**ALERT SERVICE BULLETIN**

NO. 205-10-106

**MODEL AFFECTED:** 205A /205A-1

**SUBJECT:** HIGH FORWARD CROSSTUBES, P/N 205-050-403-031, 412-050-046-101, MANDATORY INSPECTION

Figure 1

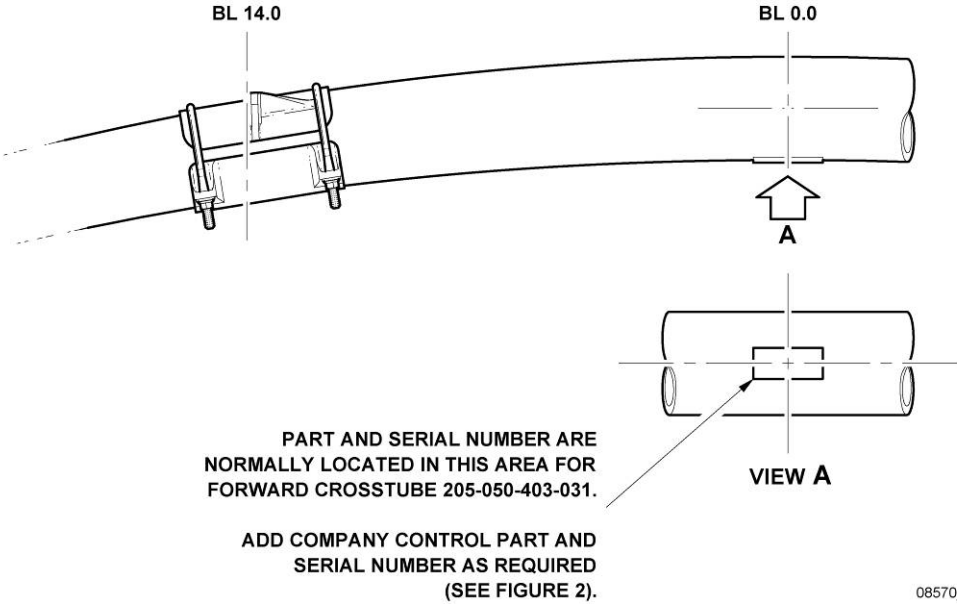
High forward crosstubes assemblies P/N 205-050-403-031 are identified by the use of a decal at BL 0.0 lower side, see Figure 1. If this decal is no longer legible or is missing, determine crosstube part number using helicopters records.

Figure 2

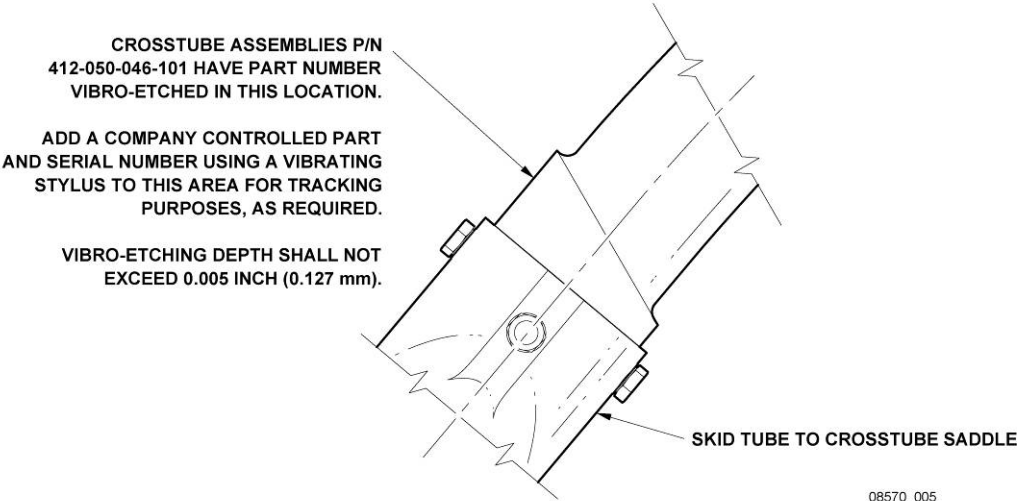
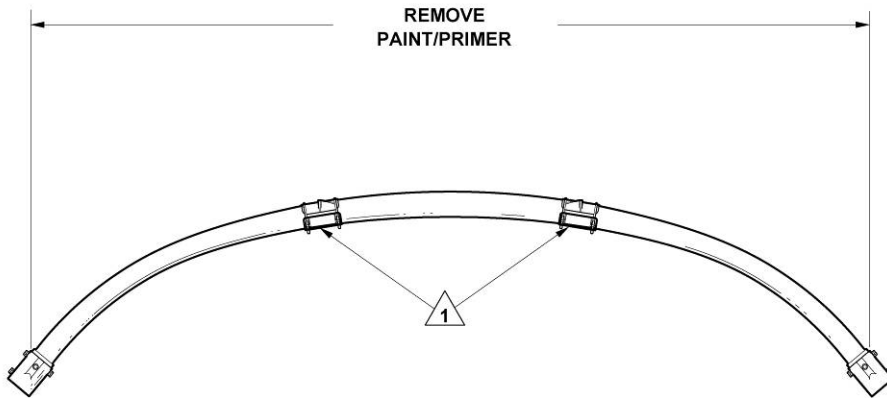
High forward crosstubes assemblies P/N 412-050-046-101 have a part number that is vibro-etched on the crosstube adjacent to the skid tube saddle as indicated in Figure 2.

3. Bell Helicopter Textron crosstubes not clearly displaying a visible part and serial number are required to be identified. The part and serial numbers are to be vibro-etched on the crosstube adjacent to the skid tube saddle as indicated in Figure 2. Vibro-etching depth of this information shall not exceed 0.005inch and shall be accomplished as indicated.

A) Crosstubes using a two piece saddle arrangement (P/Ns, 205-050-132-001, 205-050-133-001) are to indicate P/N 205-050-403-031FM and a company controlled serial number.

B) Crosstubes using the single upper saddle ( P/N 412-050-038-101) that is riveted to the crosstube and a lower composite film abrasion strip (206-050-301-109) shall indicate P/N 412-050-046-101FM and a company controlled serial number.

**Figure 3**

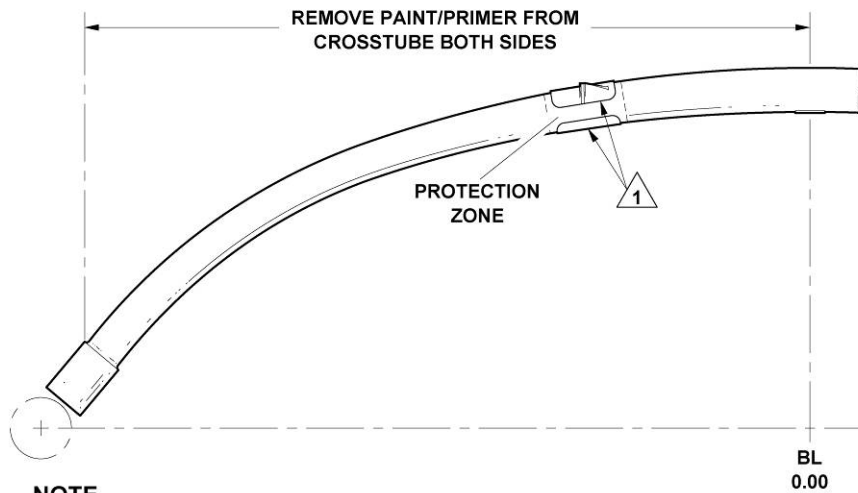
2. Prepare crosstube for the inspection process by removing the paint on the crosstube.
  - a. Crosstube P/N 205-050-403-031 will require the exterior paint to be completely removed as indicated in Figure 3. The supports P/N 205-050-132-001 and 205-050-133-001 are removed for this step, as previously indicated.
  - b. Crosstube P/N 412-050-046-101 will require the exterior paint to be removed with the exception of the BL 14 area at the upper supports and lower abrasion strips, which are to be protected as indicated in Figure 4.
3. Apply chemical paint remover (C-436) to the crosstube with a brush following manufacturer's directions and the BHT-ALL-SPM.

1 Supports P/N 205-050-132-001 (upper) and 205-050-133-001 (lower) are removed prior to paint removal.
